South Texas Project Electric Generating Station P.O. Box 289 Wadsworth, Texas 77483

February 27, 2014
NOC-AE-14003089
10 CFR 2.202

South Texas Project
Units 1 & 2
Docket Nos. STN 50-498, STN 50-499
STPNOC Second Six-Month Status Report in Response to March 12, 2012 Commission Order
Modifying Licenses with Regard to Requirements for Mitigation Strategies
For Beyond-Design-Basis External Events (Order Number EA-12-049)

**STP Nuclear Operating Company (STPNOC) Second Six-Month
Status Report for the Implementation of Order EA-12-049, Order
Modifying Licenses with Regard to Requirements for Mitigation
Strategies for Beyond-Design-Basis External Events**

Conceptual Drawing - FLEX Electrical Distribution System

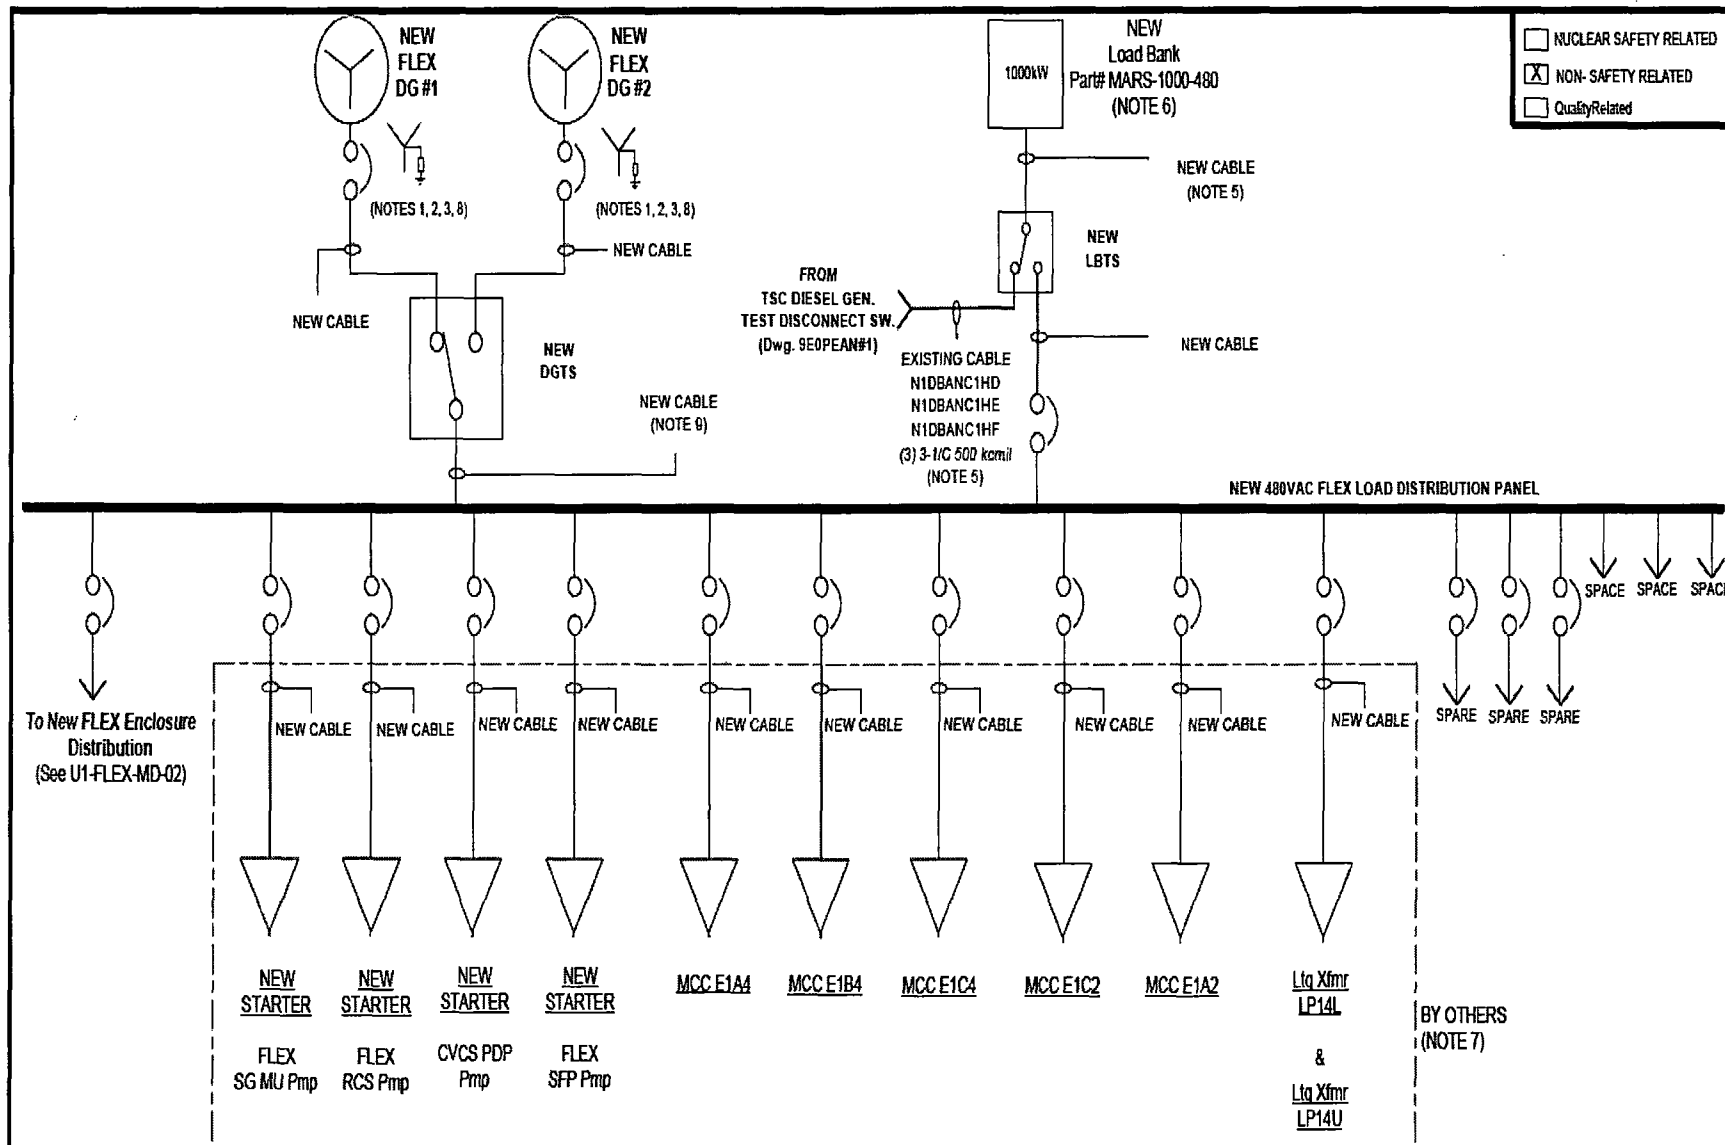
- B. The capacity of the diesel generators has been increased to 1000 kW at 480V to accommodate running more equipment.
- C. For Modes 1-4 Core Cooling, STP's strategy has been updated to:

See Attachment 2 for conceptual drawings and drawing changes planned for FLEX power distribution, SFP Makeup, RCS Makeup, and SG Makeup.

Conceptual Drawing – Spent Fuel Pool Makeup FLEX Pump

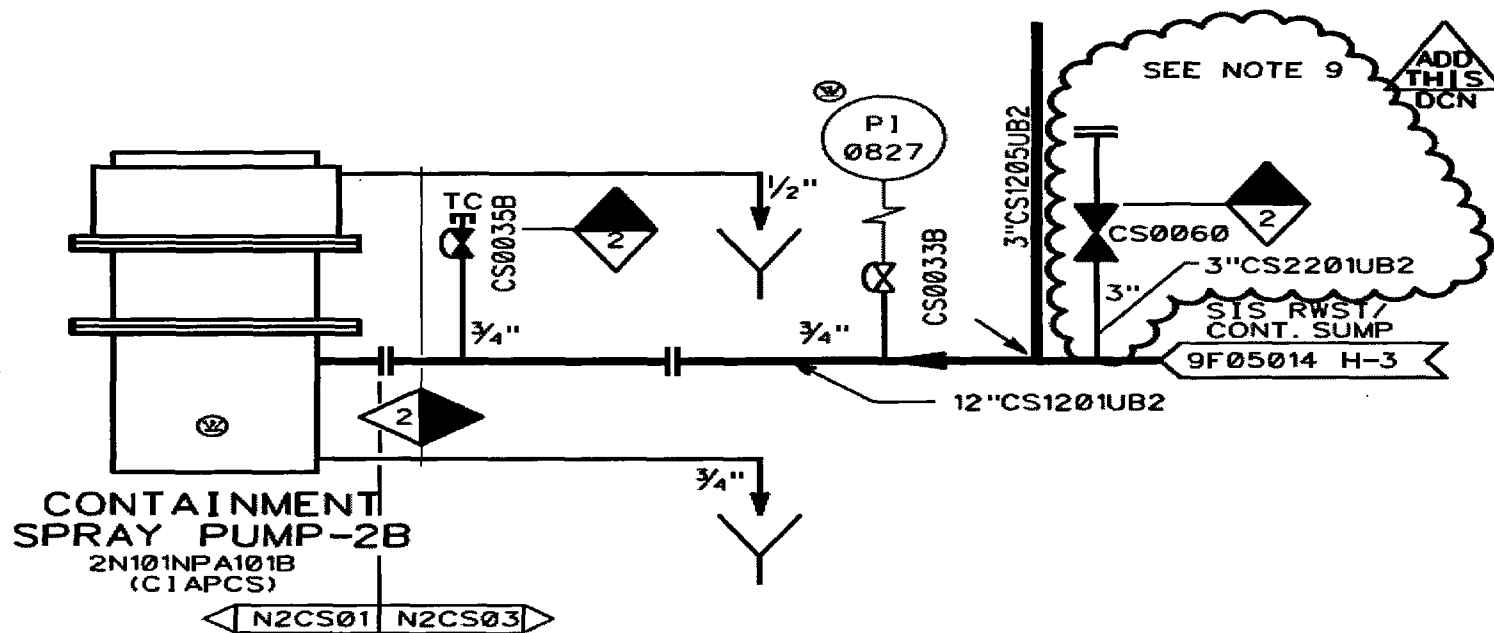
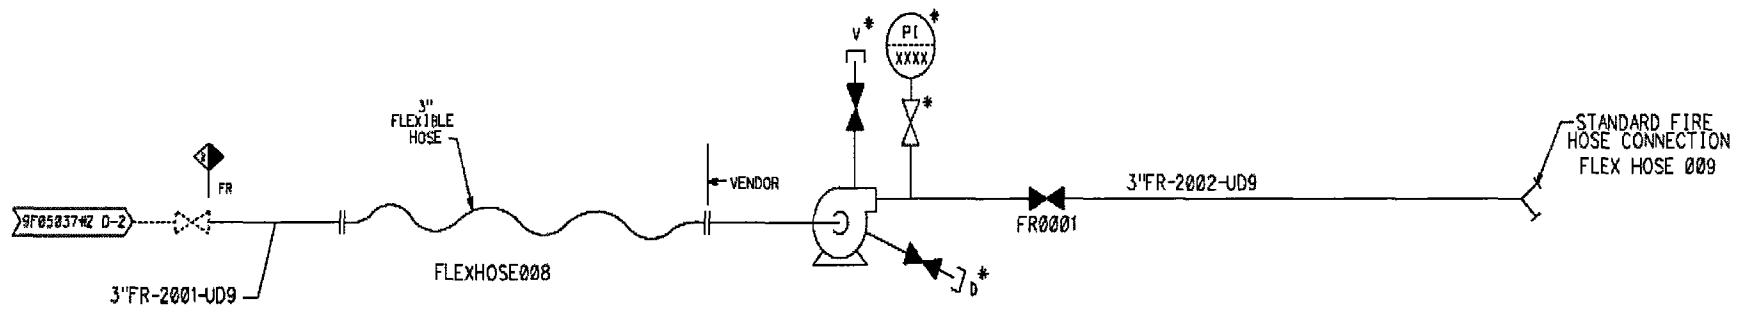
- H. The new FLEX SFP makeup pump has been updated to a rating of 250 gpm at 150 psig. This pump will be used both for makeup using hoses and for spray.

Conceptual Drawing – Reactor Coolant System Makeup

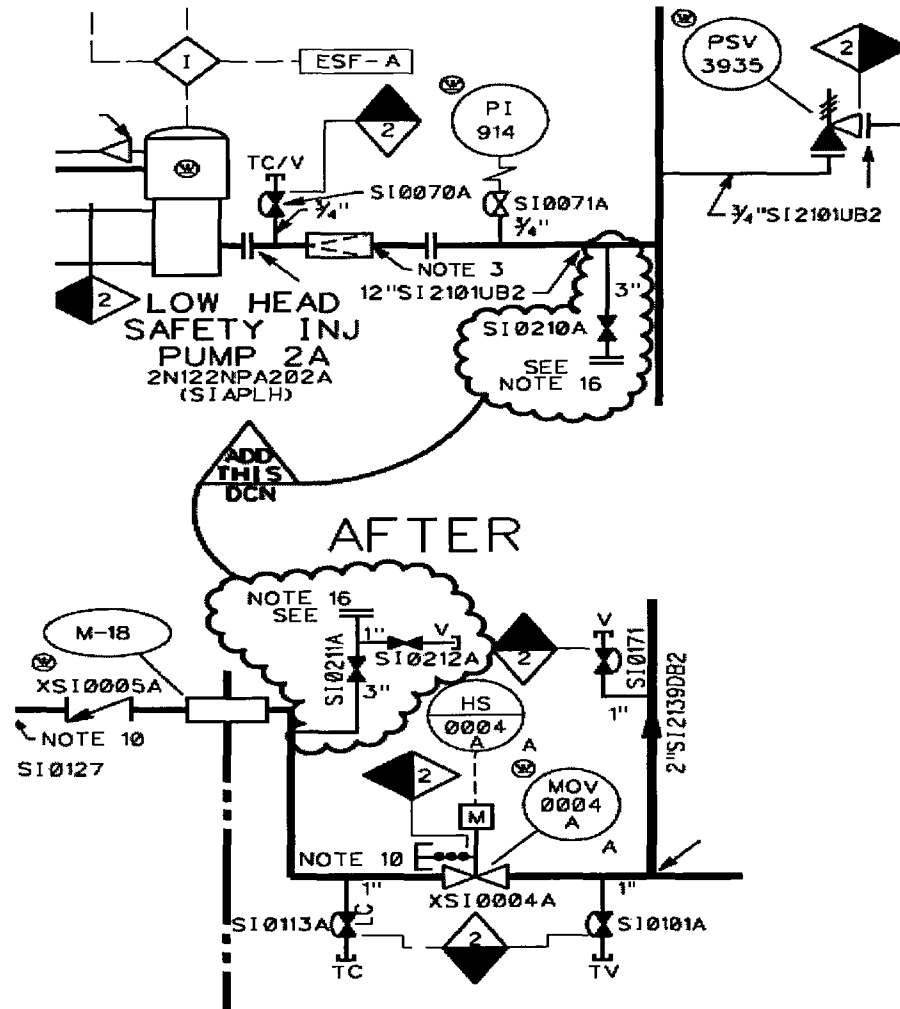
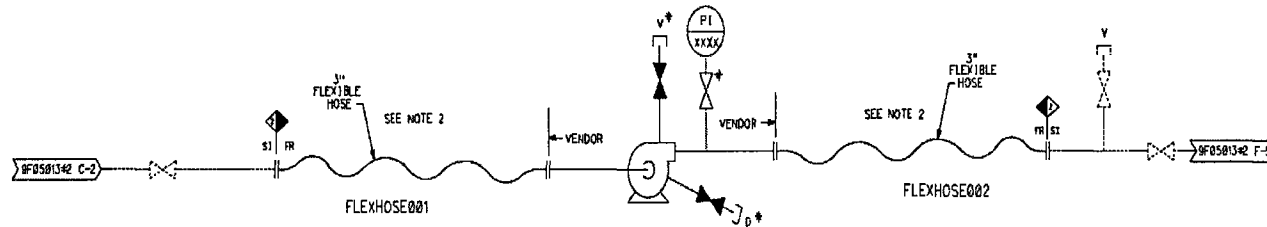
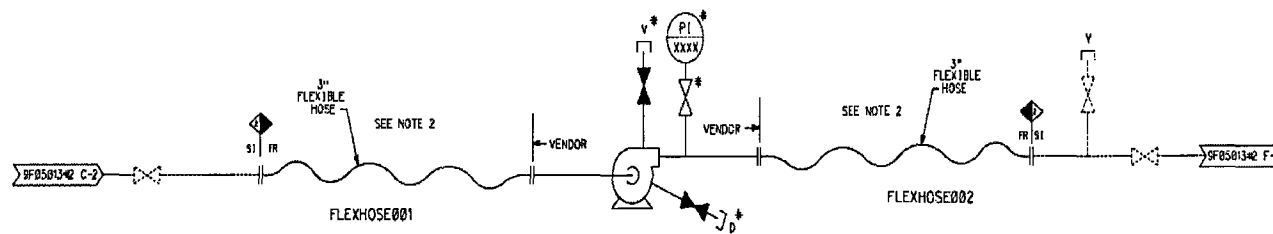
- D. The FLEX RCS Makeup pump was originally rated at 1500 psi but has been updated to a rating of 700 psi. STP can open the Reactor Head Vents as necessary during this event.

- F. The FLEX power diesel generator enclosures on top of the MAB will be made of steel vice concrete.
- G. For Modes 5 and 6 Core Cooling, a new FLEX pump rated at 170 gpm at 100 psig will be used as the primary strategy and a Boric Acid Transfer pump will be used as the alternate strategy.

Conceptual Drawing – Steam Generator Makeup (RCS Core Cooling)

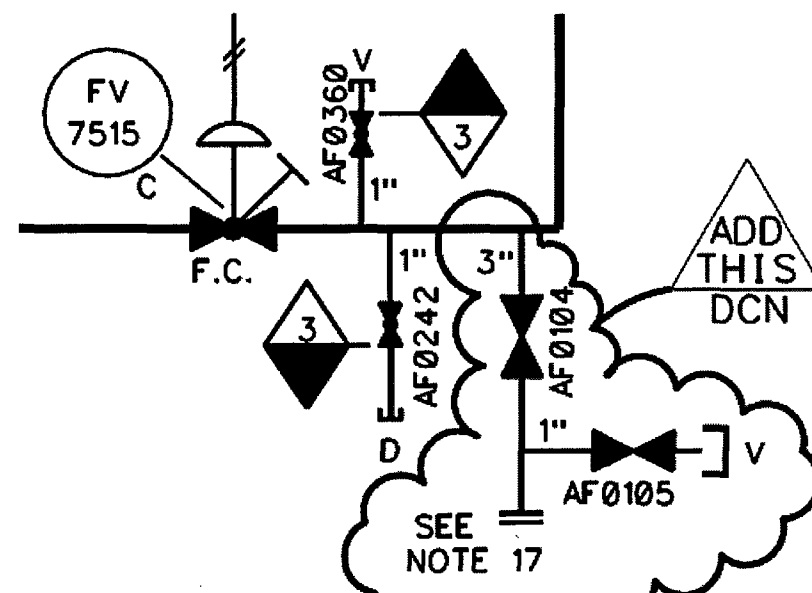
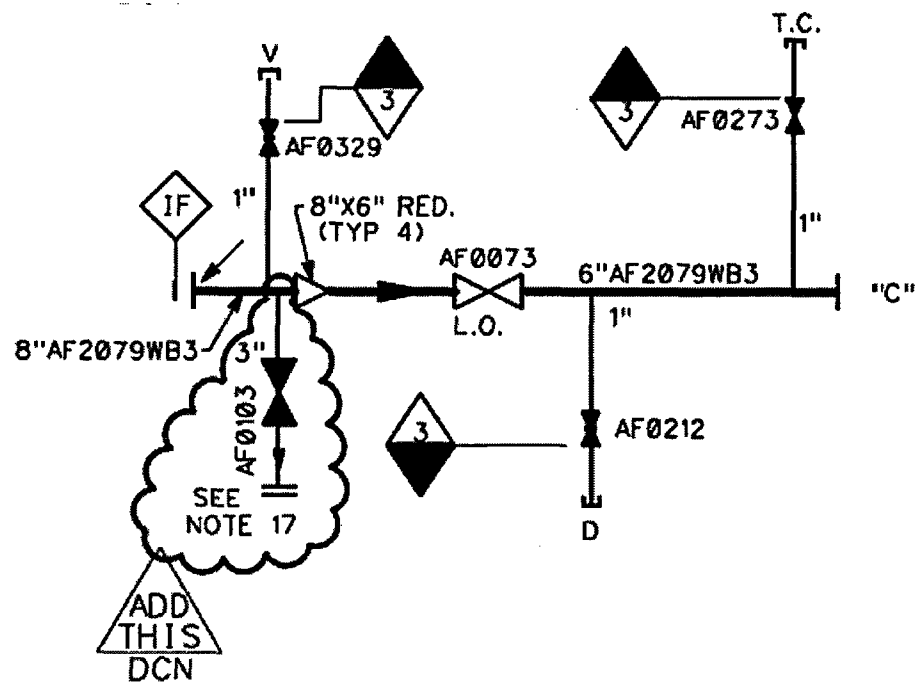
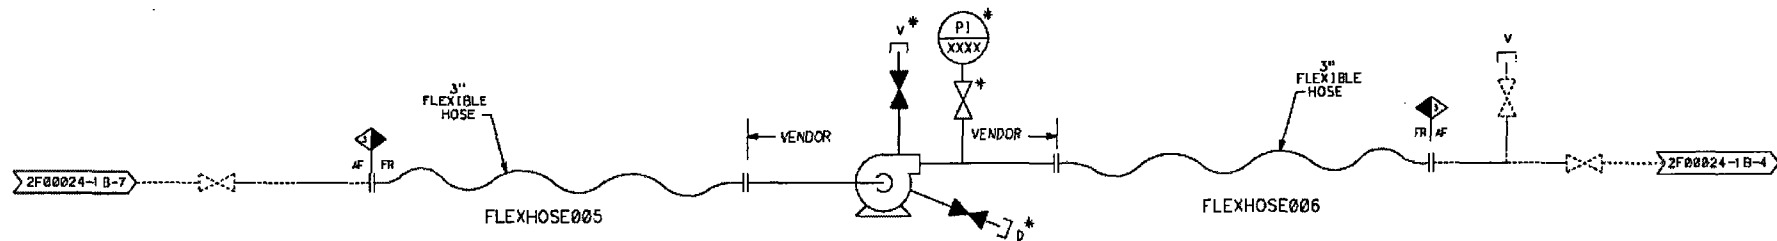
- a. Use the Turbine Driven Auxiliary Feedwater (TDAFW) pump in Phase 1.
 - b. Use the new 300 gpm at 500 psig FLEX SG fill pump as the primary strategy to back up the TDAFW pump during Phase 2.

- c. Use the trailer mounted portable diesel driven pump feeding the Main Feedwater lines as the alternate strategy. This strategy cannot be used for about 72 hours following a Main Reservoir embankment breach flood but can be used immediately for all other external events.
